Index 102-613 Multilane, Work Within the Travel Way – Median or Outside Lane

COMMENTS AND RESPONSES

102-613 Sheet 5 of 5

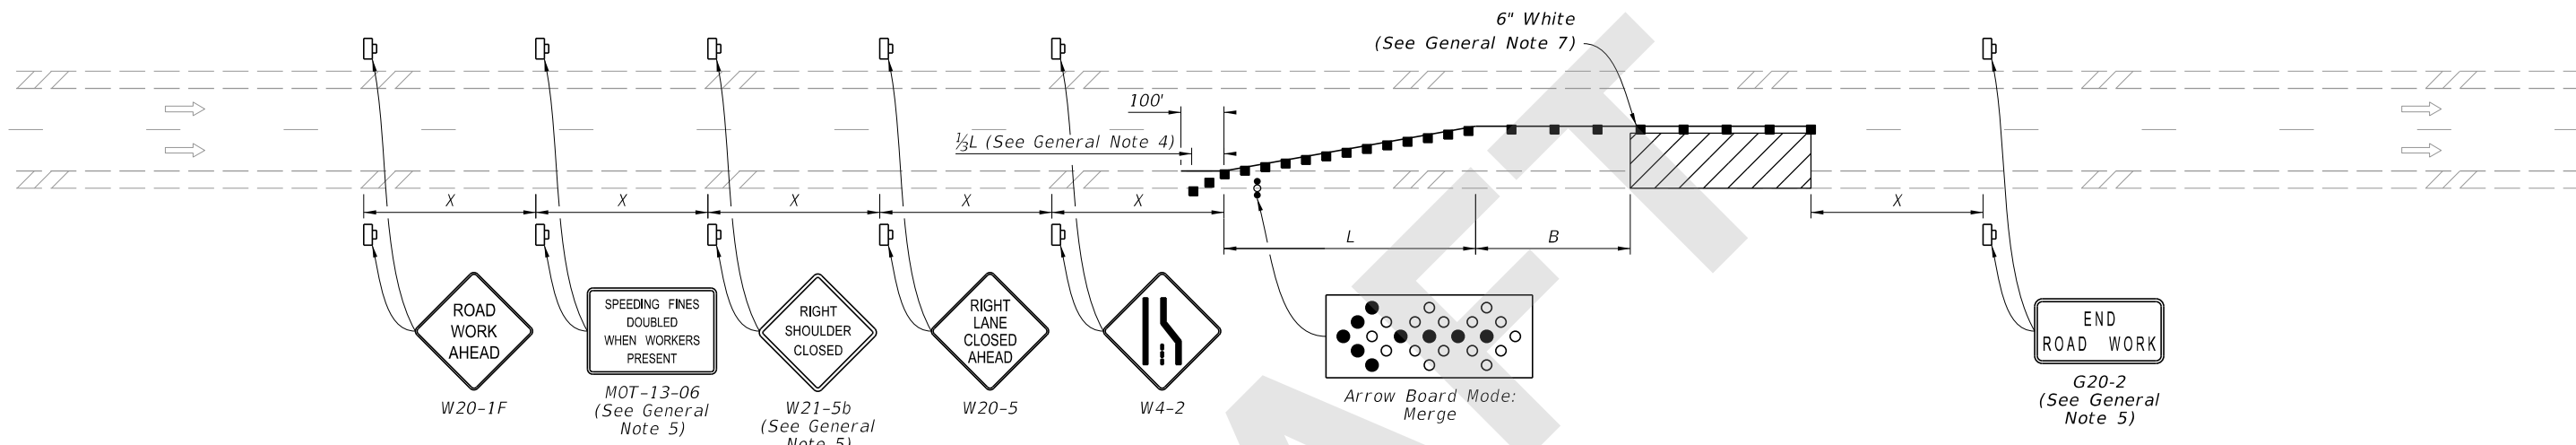
Sheet 5: Note 2. The last sentence isn't clear. Is the department intending for the display speed on the PRS to be 55 mph when the posted speed limit is 55mph?

3. Sheet 5: Note 2 is somewhat confusing, consider deleting the last sentence

4. Sheet 5: W20-XX on diagram is confusing... it looks like you intend continuation of normal setup signs, there was a good example of that earlier in the set

Note shown in detail “Remainder of Work Zone Signs and Devices in accordance with the Plans and Standard Plans”, AND, Note 1. “When called for in the Plans, use the MAS in accordance with the Plans and this Index. When using this detail, place the MAS devices in advance of the “Road Work Ahead” sign (W20-1F) as shown.”

QUESTION: Does this mean that **all** the signs that would otherwise be required (say for a lane closure) as shown on Sheet 1 of 5 be required also, ie. duplication of Road Work Ahead, Speed Fines Doubled, Right Lane Closed Ahead signs?

RESPONSE: Agreed, additional clarification of the note is needed.

RESPONSE: Agreed, the sentence was rewritten for clarity.

RESPONSE: Agreed, the detail and Note #1 was updated to clarify the intent.

RESPONSE: The intent is for the MAS units to be intermixed with the signage, not in addition to. Based on this comments and others similar, the Notes and Detail have been revised for clarity.
Change Made

LAST REVISION 11/01/20	REVISION	DESCRIPTION:	 FY 2021-22 STANDARD PLANS	MULTILANE ROADWAY, LANE CLOSURES	INDEX 102-613	SHEET 1 of 5
---------------------------	----------	--------------	--	---	-------------------------	------------------------

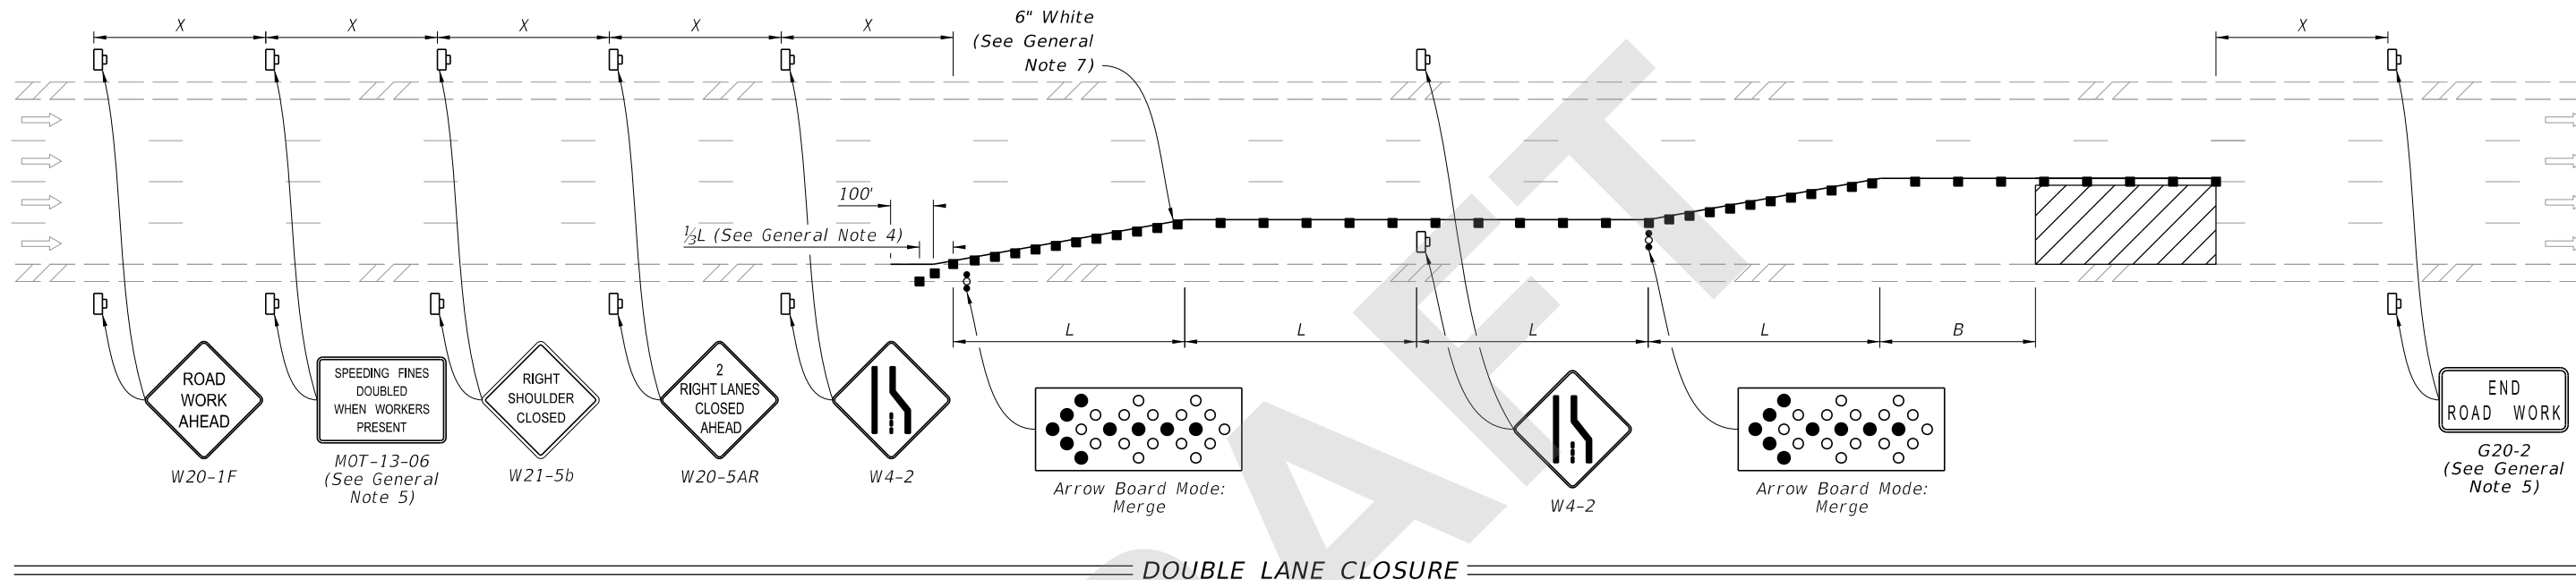
1. Sheet 1: Why are the channelizing devices removed in front of the work area?

RESPONSE: The channelizing devices are no longer applicable because Specification 102 requires all vehicles in the work area to have SAE J595, Class 2 warning lights.

LAST REVISION 11/01/20	REVISION	DESCRIPTION:	 FY 2021-22 STANDARD PLANS	MULTILANE ROADWAY, LANE CLOSURES	INDEX 102-613	SHEET 4 of 5
---------------------------	----------	--------------	--	----------------------------------	------------------	-----------------

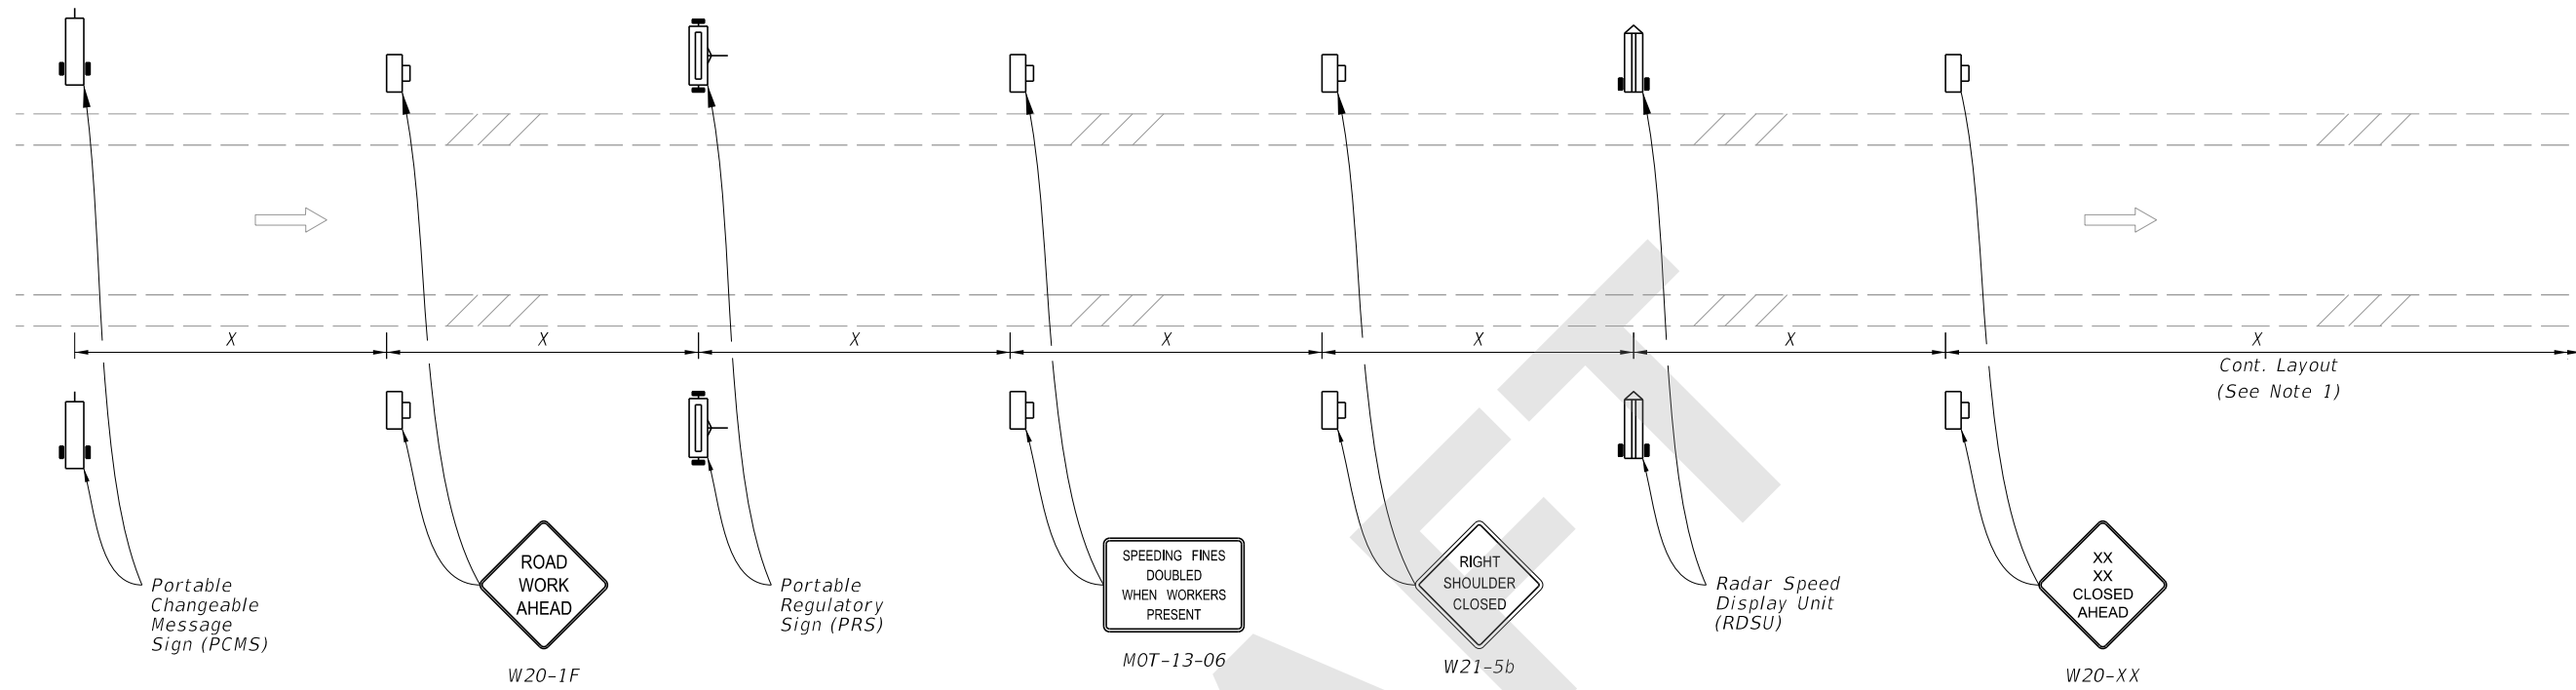
Sheet 4: is the intent to use a solid 6" white separating the lanes on the tangent, regardless of the length? I'd assume that if the tangent length is greater than a certain distance, a skip line could be used.

3. Sheet 4: Why did was the 500 feet advance warning sign removed?

RESPONSE: Temporary Pavement Markings must meet the requirements of the FDOT Design Manual (FDM), Chapter 230, MUTCD Section 3A & 3B, and be shown in the TTC Plans.

RESPONSE: All TTC Typical Applications included in Indexes 102-601 thru 102-680 have been reevaluated and re-detailed for simplicity and consistency throughout.
